## Service Campaign 63-07

**AFFECTED:** Certain 2013 Winnebago and Itasca coaches built with Schwintek In Wall Slideout Systems.

**SUBJECT:** Slideout control module and stop upgrade.

# Service Campaign: 63-07, Tube Stops and Module Replacement

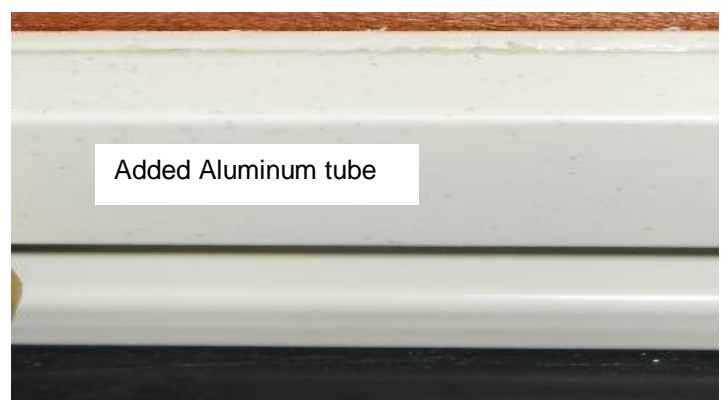
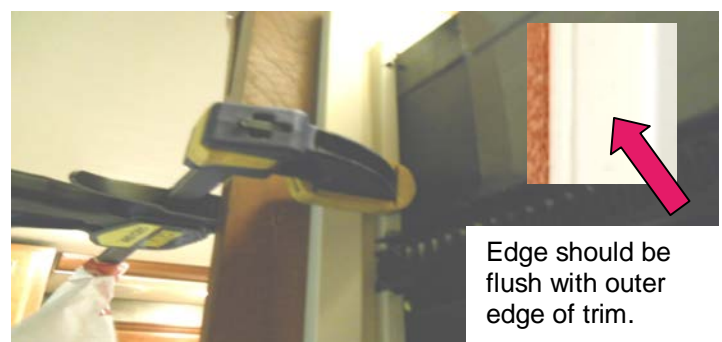
Procedure consists of removal of inside face trim (Bulb seal) and installation of aluminum tube to act as hard stop.

1. Slideout should be in retracted position. Remove inside vertical and top horizontal face trim bulb seals and discard. Clean trim face of tape residue.
2. Measure tubes to be installed on vertical face trim. Cut to length and dry fit tubes. Apply 1/4" bead of adhesive to aluminum tube that will be installed on inside face trim.
3. Install tube on front and rear vertical face trim making sure it is flush with outer edge of trim. Clamp into place until adhesive sets up. May need to remove excess adhesive.
4. Measure tubes to be installed on top face horizontal trim. Cut to length and dry fit tubes. Apply 1/4" bead of adhesive to aluminum tube. Install tube on top face trim and clamp in place, until adhesive sets up, making sure it is flush with edge of face trim.
